Road Safety Audit

Lucan to City Centre

Core Bus Corridor Scheme
Stage 1 Road Safety Audit Report

Date September 2022

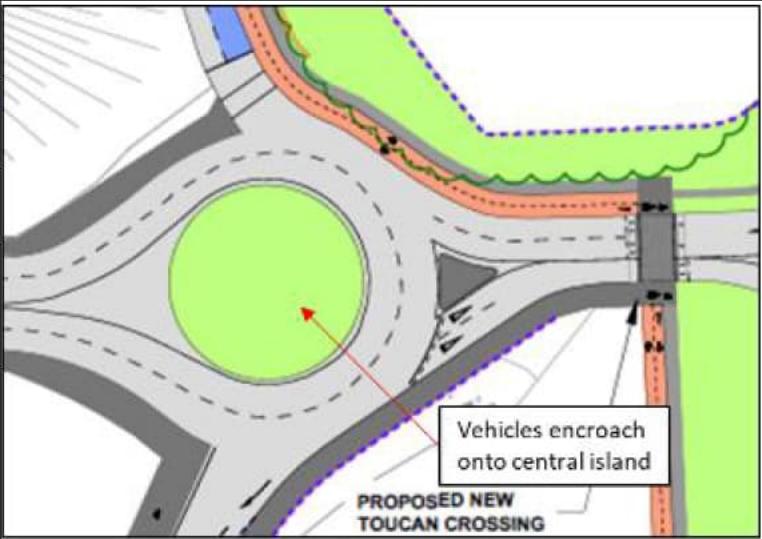
4.3.7 Problem	 
Location: Westbound Bus Stop to the west of Ballyowen Lane	
Drawing: Sheet 03 of 32	
Summary: Bus stop is too short	
Description: The westbound bus stop located to the west of Ballyowen Lane is too short in length. The bus stop does not have sufficient capacity to accommodate more than a single bus. This results in buses having to stop on the carriageway when there is already a bus occupying the bus stop. This will increase the risk of rear end shunt collisions with buses required to stop on the carriageway while waiting for another bus to depart the bus stop.	
Recommendation:	Provide a bus stop longer in length so it can accommodate more than a single bus.

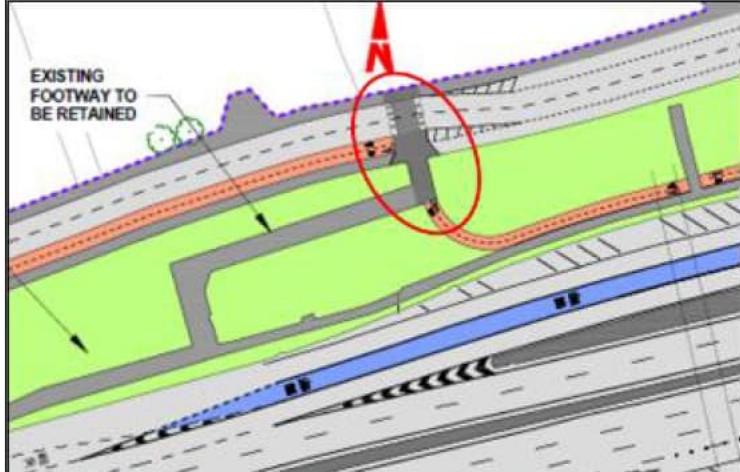
4.3.19 Problem	
Location:	N4 to the west of Junction 1 – both carriageways
Drawing:	Sheets 08 & 09 of 32
Summary:	High speeds observed at this location

Description:	Figure 3.5 Speed limit on eastbound approach to M50 interchange During the site visit it was observed that vehicles appeared to be travelling in excess of the posted speed limit. The provision of an additional bus lane, particularly on the eastbound approach, increases the complexity of the road layout. The existing speed limit on the approach may be unsuitable for the proposed layout and result in an increase in collisions.
Recommendation:	An assessment of the existing speed limits should be undertaken by the designers. If the speed limit is deemed unsuitable, discussions with TII should be undertaken with regard to reducing the speed limit at this location.

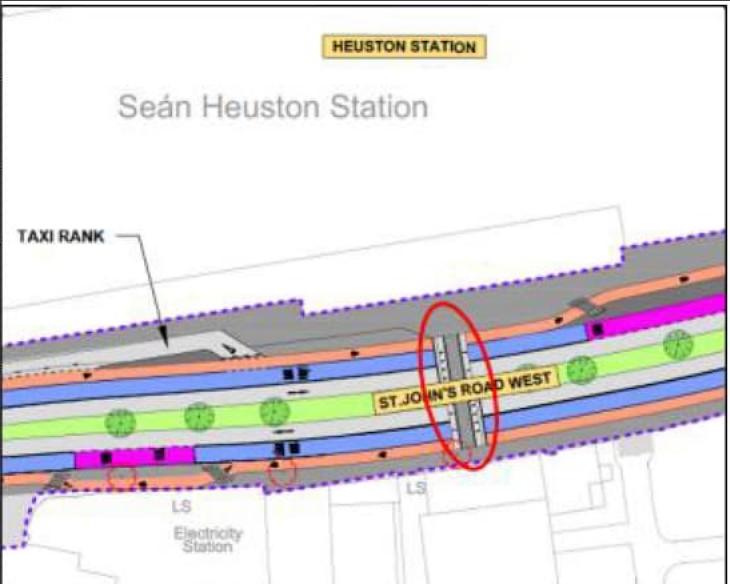
4.3.36 Problem	 <p>The diagram shows a cross-section of the area around Seán Heuston Station. It features a 'TAXI RANK' at the top left. A road labeled 'ST.JOHN'S ROAD WEST' runs diagonally from the bottom left towards the top right. A red circle highlights a narrow speed bump or speed hump installed across the road. The area is surrounded by various buildings and infrastructure, including an 'Electricity Station'. Labels 'LS' are present near the base of the ramp.</p>
Location:	Heuston Station drop-off

Drawing:	Sheet 31 of 32
Summary:	Width of peed ramp is too short
Description:	<p>The speed ramp proposed on St. John's Road West adjacent to Heuston Station is too narrow for buses. This could result in ground of buses as they negotiate the ramp and possibly collisions. Increasing the length of the flat-top ramp is favoured by buses as they perceive it to reduce the discomfort for drivers and passengers together with maintenance and repair costs for their vehicles.</p>
Recommendation:	<p>A minimum flat-top length of 6m on bus routes, a height of 75mm together with ramp slopes of 1 in 15 should be installed as this represents a good balance between effective speed reduction and the potential drawbacks. This is in line in line with the requirements of the Traffic Management Guidelines.</p>

4.3.36	Yes	Yes		Ramp widths at this location have been increased to 4.5m to accommodate both pedestrians and cyclists.	
4.3.37	Yes	Yes		Traffic island widths have been amended to provide sufficient capacity for cyclists travelling through the junction.

Figure 3.11 Narrow pedestrian refuges

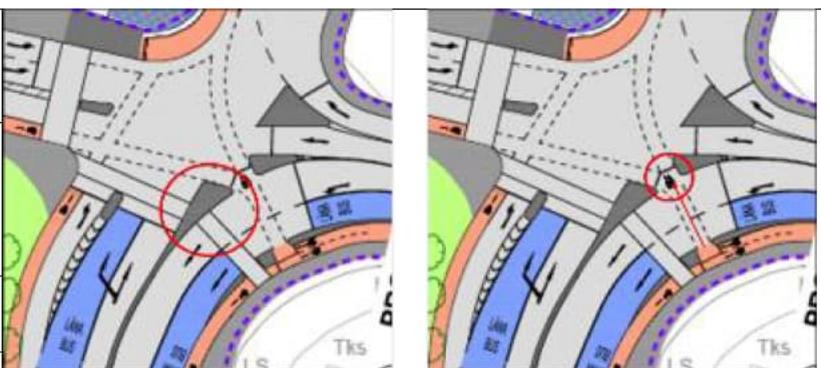
4.3.37 Problem	
Location:	St. John's Road West/Frank Sherwin Bridge/Victoria Quay junction
Drawing:	Sheet 31 of 32
Summary:	Refuge areas are too small for pedestrians and cyclists crossing the junction
Description:	<p>The refuge island at the pedestrian crossings at the St. John's Road West/Frank Sherwin Bridge/Victoria Quay junction is too narrow to accommodate the large volumes of pedestrians that are present at this location on a daily basis. The insufficient width is likely to result in pedestrians encroaching on the adjacent carriageway with the risk of being struck by vehicles.</p> <p>In addition, cyclists crossing the junction from Victoria Quay towards Frank Sherwin Bridge have a very restricted waiting area. Again, when there are large volumes of cyclists crossing at the same time, there is a risk that a cyclist will encroach on the carriageway while waiting to cross the junction towards Frank Sherwin Bridge, with the risk of collisions.</p>

Recommendation:	
The size of the pedestrian refuge islands should be increased at this location. The waiting area of cyclists should also be extended.

Problem: 4.1.1

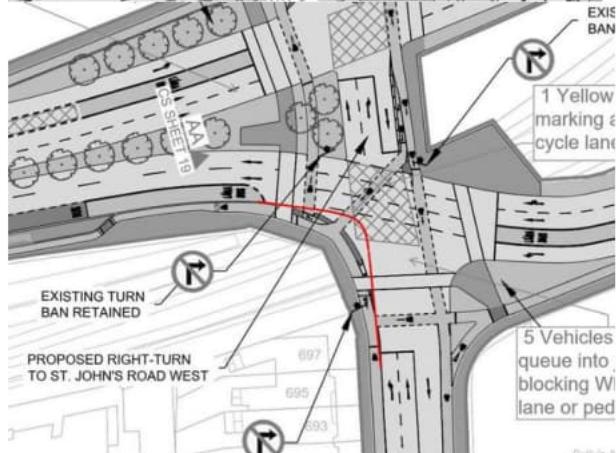
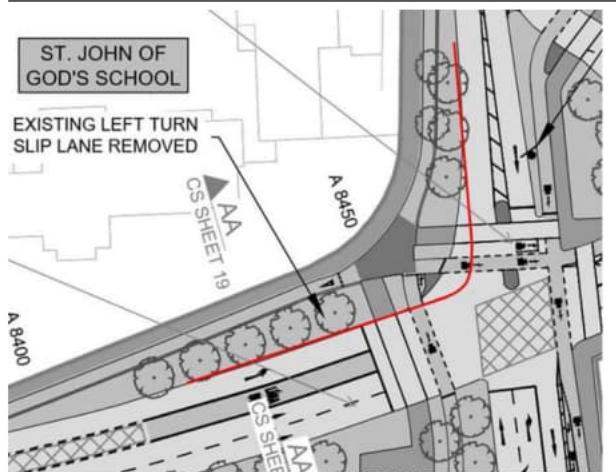
Summary: Differences in drawing series can lead to incorrect provisions.

It is noted that there are several inconsistencies of the cycle layouts between the separate drawing series. For example, as shown above at the R835 Lucan Road / R136 Ballyowen Road junction, when comparing the General Arrangement drawing to the Traffic Signs & Road Marking drawing, the alignment of the cycle crossings are different on the R136 Ballyowen Road for each drawing. The radii of the cycle tracks on the north-eastern side of the junction area are different. Also, the location of the western cycle right turn waiting area northbound on the Lucan Road is located at different positions either side of the Lucan Road pedestrian crossing. Inconsistencies in layout arrangement on construction drawings can lead to unsafe layouts and road markings which can result in pedestrian and cyclist collisions and injuries.

Ensure the proposed layout is consistent across all proposed drawing series.

4.1.1	Yes	Yes		Preliminary Design drawings to be fully aligned with General Arrangement plans.	
4.1.2	Yes	Yes		Corner radii for urban junctions have been generally designed in accordance with DMURS section 4.3.3 and assessed/adjusted following vehicle swept path tracking assessments. DMURS states 6m is an appropriate general radius to allow larger rigid vehicles to turn without overrunning whilst keeping car speeds low.

Drawing(s): BCIDA-ACM-GEO_GA-0006_XX_00-DR-CR-0001 of 31

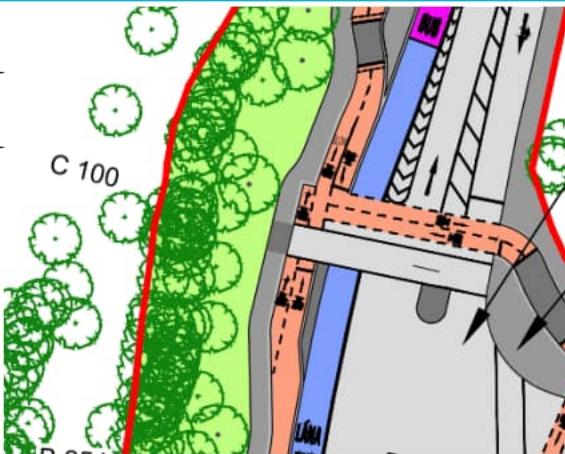
Summary: Lack of cycle push-button facilities can lead to cyclist/pedestrian collisions.

Provide low level cycle signals in both directions at all signalised pedestrian crossings to allow cyclists to identify when it is safe to proceed through the pedestrian crossing.

Drawing(s): BCIDA-ACM-GEO_GA-0006_XX_00-DR-CR-0001 of 31

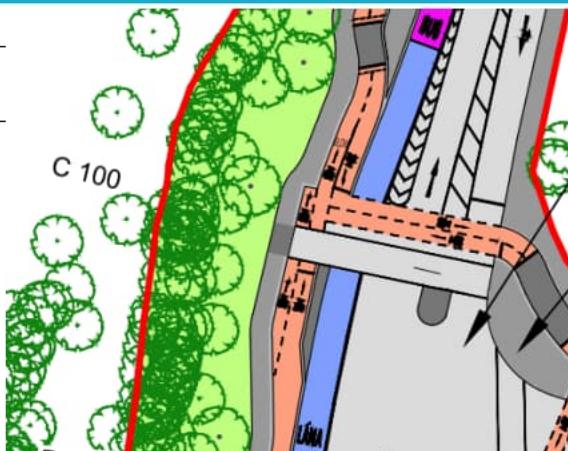
Summary: Lack of tactiles and signage can lead to cyclist/pedestrian collisions.

Ensure that dropped kerbs and appropriate tactile tramline paving, with visual contrast, are provided on the cycle track and at NMU crossing locations and in accordance with the Traffic Management Guidelines, particularly at the bus stops and in areas where the footpath crosses the cycle track. Also provide appropriate tramline tactile paving on the cycle track in advance of all pedestrian crossing locations.

Drawing(s): BCIDA-ACM-GEO_GA-0006_XX_00-DR-CR-0001 of 31

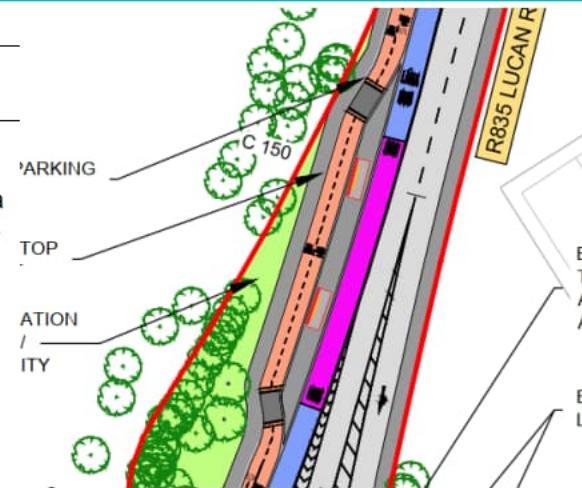
Summary: Risk of pedestrians sustaining personal injuries when attempting to transition between footway and bus boarding area due to lack of crossing across cycleway.

4.2.3	Yes	Yes		Pedestrians are to be given priority at the crossing points across the cycle tracks at the bus stops. Further detail in accordance with the BCPDGB & the NCM to be shown at detailed design stage.

Drawing(s): BCIDA-ACM-GEO_GA-0006_XX_00-DR-CR-0001 of 31

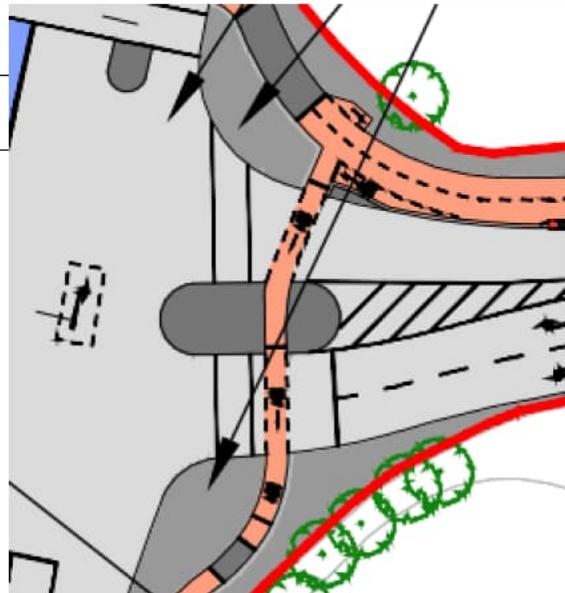
Summary: Insufficient cycle storage on splitter island could lead to pedestrian/vehicle or cycle/vehicle collisions.

Drawing(s): BCIDA-ACM-GEO_GA-0006_XX_00-DR-CR-0001 of 31

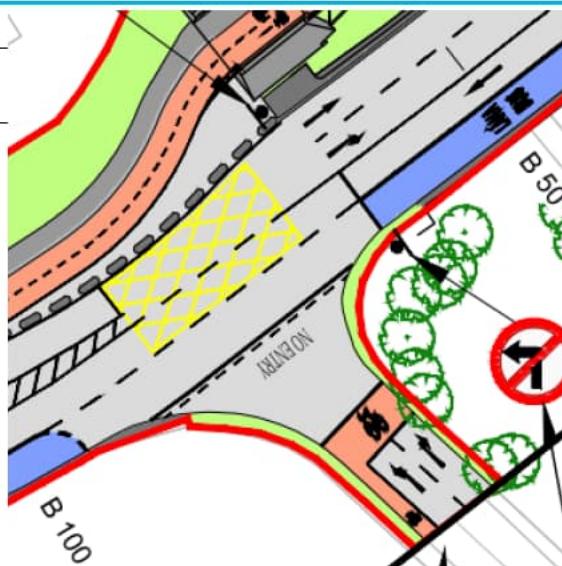
Summary: Restricted access to the cycle track can lead to cycle/vehicle collisions.

Provide clear directional signage and access arrangements for cyclists from the N4 off-slip road to safely access the proposed cycle tracks on the R138 Ballyowen Road.

Drawing(s): BCIDA-ACM-GEO_GA-0006_XX_00-DR-CR-0003 of 31

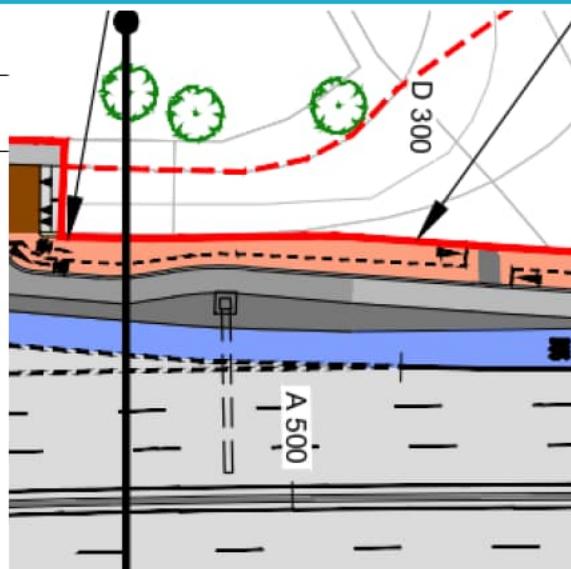
Summary: Narrow bus lane could result in vehicle side swipe collisions.

Provide sufficient width on the proposed bus lane at tie-in locations to ensure that buses do not overhang into the adjacent traffic lane.

Drawing(s): BCIDA-ACM-GEO_GA-0006_XX_00-DR-CR-0004 of 31

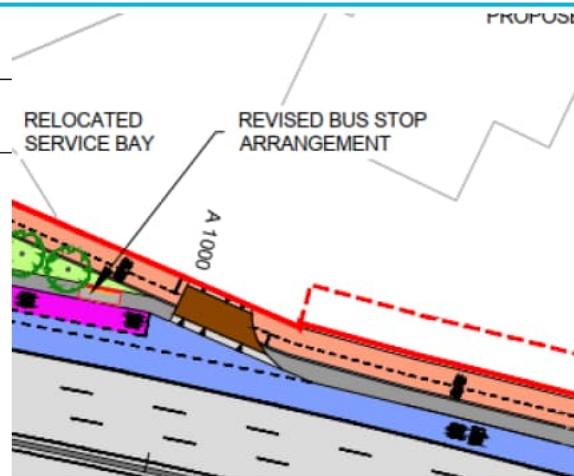
Summary: Risk of visually impaired or wheelchair users crossing on a slope could lead to falls.

Provide a flush finish across the entire width of all footpath crossings and cycle tracks on raised tables or at a minimum, provide a flush finish across the extent of the tactile paving at the footpath crossing.

Drawing(s): BCIDA-ACM-GEO_GA-0006_XX_00-DR-CR-0004 of 31

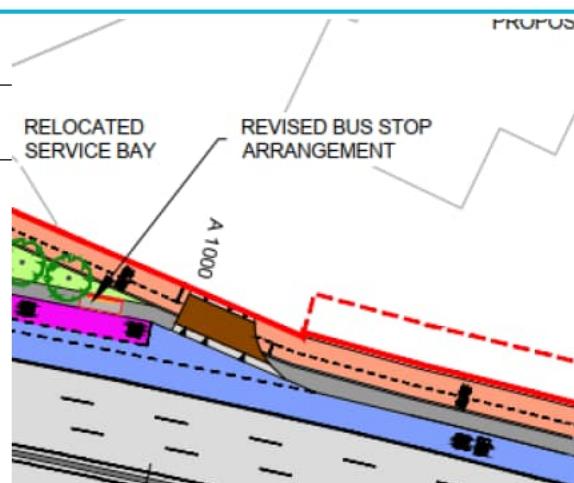
Summary: Risk of visually impaired pedestrians misinterpreting crossing.

Drawing(s): BCIDA-ACM-GEO_GA-0006_XX_00-DR-CR-0004 of 31

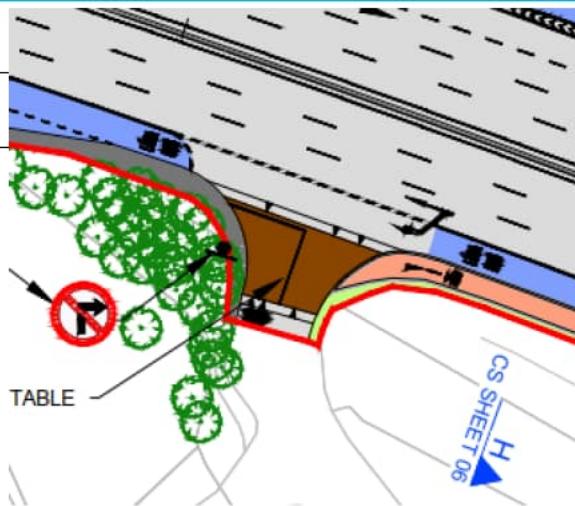
Summary: Cycle route terminates without onward direction.

Provide clear direction to enable cyclists to continue their journey in a safe environment to minimise conflict with vehicles and pedestrians.

4.2.10	Yes	Yes		Cycle signage not shown for clarity - to be added at detailed design stage.	
4.2.11	Yes	Yes		The existing spur is to be removed.	
4.2.12	Yes	Yes		A pedestrian crossing is being provided adjacent to the Deadman's Inn

Drawing(s): BCIDA-ACM-GEO_GA-0006_XX_00-DR-CR-0006 of 31

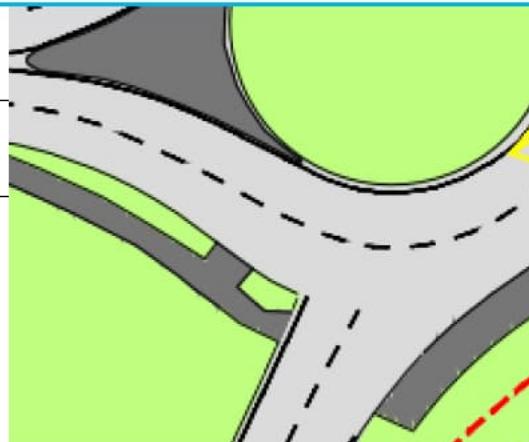
Summary: Proposed footpath link directs NMUs into the carriageway.

Remove this footpath link and provide adequate facilities at pedestrian crossing points.

Drawing(s): BCIDA-ACM-GEO_GA-0006_XX_00-DR-CR-0007 of 31

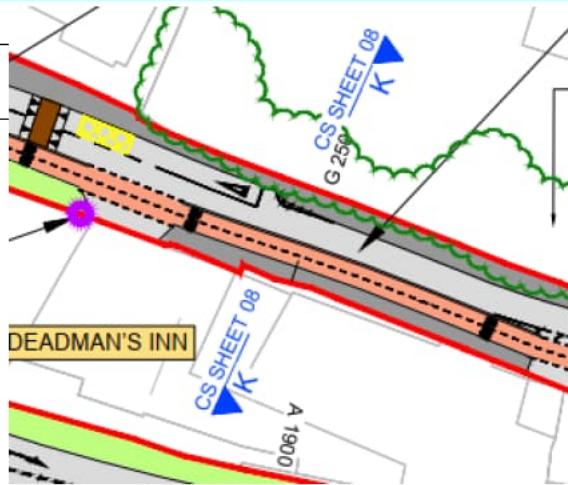
Summary: No pedestrian crossing facility is provided across the Old Lucan Road.

Drawing(s): BCIDA-ACM-GEO_GA-0006_XX_00-DR-CR-0007 & 0008 of 31

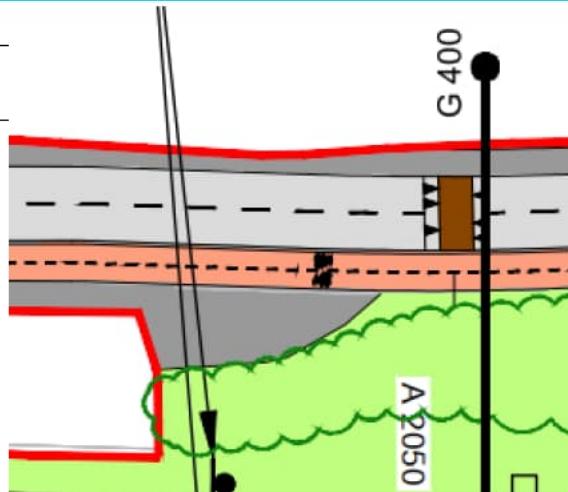
Summary: Cars may park on the cycle track on the Old Lucan Road.

There is currently uncontrolled on-street car parking along the southern side of the Old Lucan Road. As there is a bus stop a short distance away, this section of the Old Lucan Road may be used as a parking area for city bound bus users. If alternative sufficient parking facilities are not provided to replace the current on-street parking, this can lead to cars parking in the cycle track. This will result in cyclists having to veer into and out of the Old Lucan Road carriageway, which could result in a cyclist/vehicular collision.

Provide sufficient off-street parking to accommodate existing parking usage or provide adequate cycle track segregation and protection so that vehicles would not be able to enter the cycle track.

Drawing(s): BCIDA-ACM-GEO_GA-0006_XX_00-DR-CR-0008 of 31

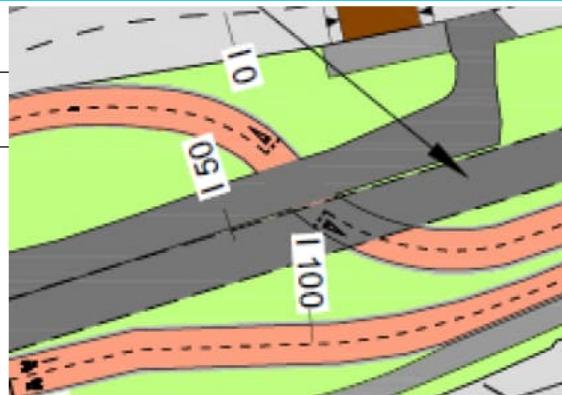
Summary: A steep gradient on the proposed cycle track may cause cyclists to lose control

Provide appropriate gradient on the cycle track.

Drawing(s): BCIDA-ACM-GEO_GA-0006_XX_00-DR-CR-0011 & 0012 of 31

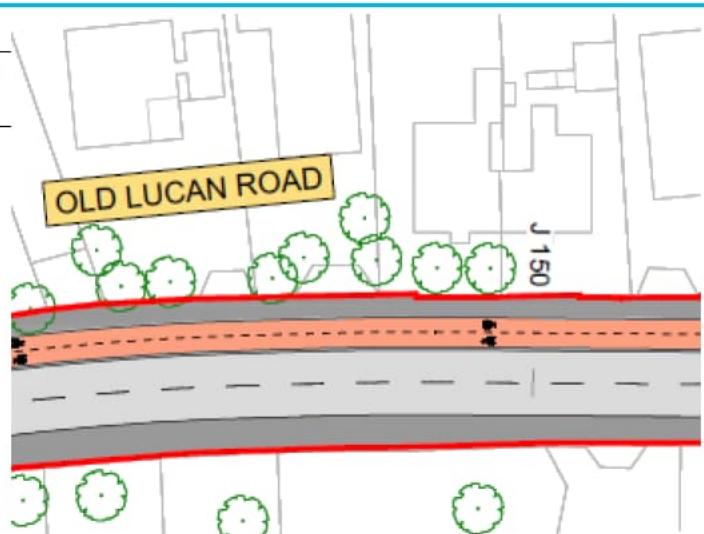
Summary: Vehicles may park on the cycle track on the Old Lucan Road.

There is uncontrolled on-street parking along the northern side of the Old Lucan Road. If alternative sufficient parking facilities are not provided to replace the current on-street parking, this can lead to cars parking in the cycle track. This will result in cyclists having to veer into and out of the Old Lucan Road carriageway, which could result in a cyclist/vehicular collision.

Provide adequate cycle track segregation and protection so that vehicles would not be able to enter the cycle track.

Drawing(s): BCIDA-ACM-GEO_GA-0006_XX_00-DR-CR-0014 of 31

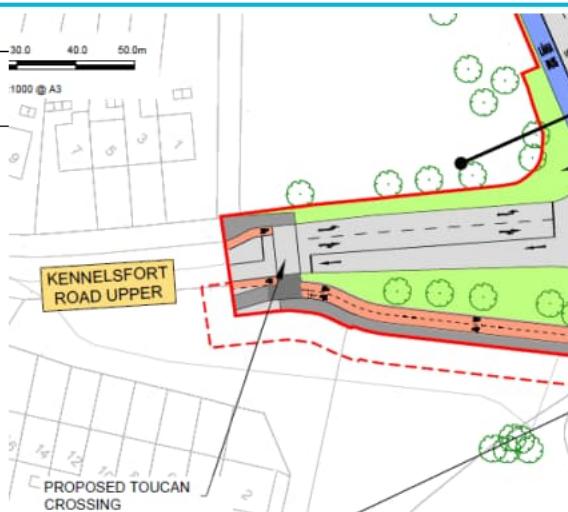
Summary: Risk of left turning vehicles striking and injuring cyclists.

Provide clear cycle route road marking and directional signage at this junction. Also, if it is the intention to direct cyclists straight ahead, provide a cycle storage area in advance of the northbound vehicular stop line on Kennelsfort Road Upper to allow cyclists to select their destination lane without having to manoeuvre across following traffic.

4.2.20	Yes	Yes		"There is no destination left & cyclist should cross at the Toucan provided to access the two-way facility via the new crossing on the R148. Directional signage for cyclists is not shown for clarity and is to be added at detailed design stage."

Drawing(s): BCIDA-ACM-GEO_GA-0006_XX_00-DR-CR-0014 of 31

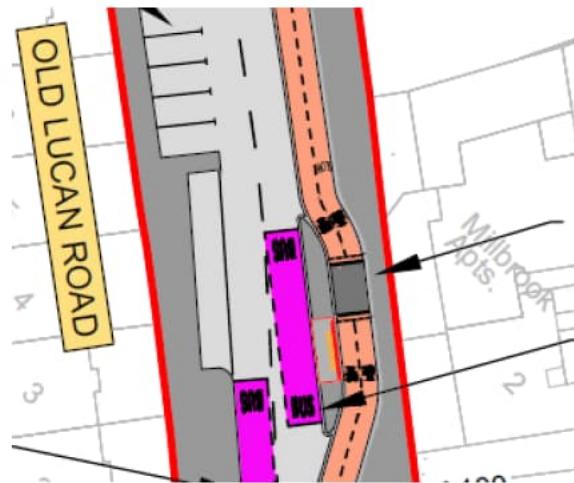
Summary: Risk of pedestrians sustaining personal injuries when attempting to transition between footway and bus boarding area due to lack of crossing across cycleway.

Drawing(s): BCIDA-ACM-GEO_GA-0006_XX_00-DR-CR-0014 of 31

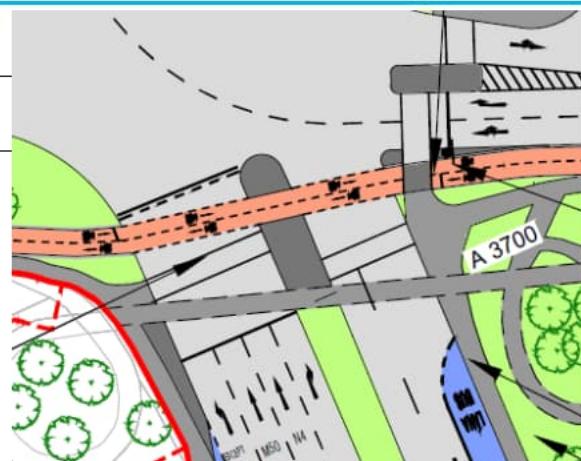
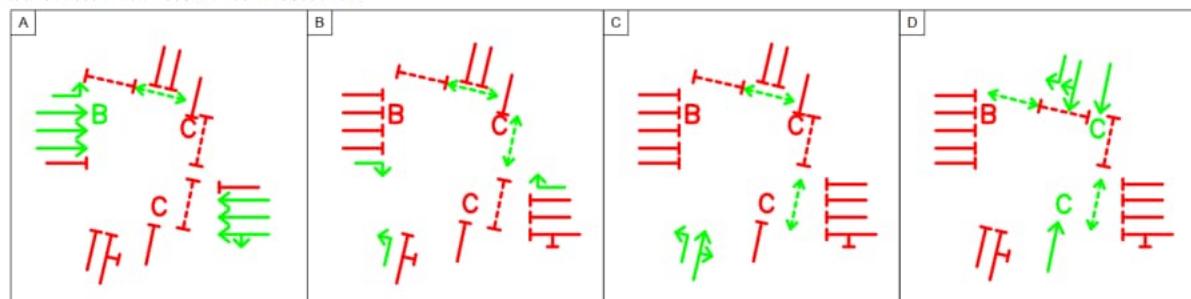
Summary: Risk of pedestrians crossing the R148 carriageway when it is not safe to do so and being struck and injured by vehicles.

The signal staging diagram for the R148 Palmerstown Bypass/Kennelsfort Road is illustrated in the image above. It shows the 4 no. stages of the traffic signals at this junction, with the pedestrian movement across the R148 eastbound indicated in Stage B. Pedestrians crossing the R148 Palmerstown Bypass from the Kennelsfort Road Upper on the first pedestrian crossing signal stage 'C' are held on the central splitter island for 2 no. signal stages before they can cross the R148 eastbound carriageway to Kennelsfort Rd Lower at stage 'B'. Signal stage 'D' facilitates the green stage for cyclists to cross to and from the Kennelsfort Road Upper and Lower. There is a Red aspect on the pedestrian signals crossing the eastbound carriageway on this stage.

Provide appropriate signal phasing to minimise pedestrian waiting times on all central splitter islands. If it is safe to do so, give northbound pedestrians a green light to cross the R148 eastbound during signal stage D.
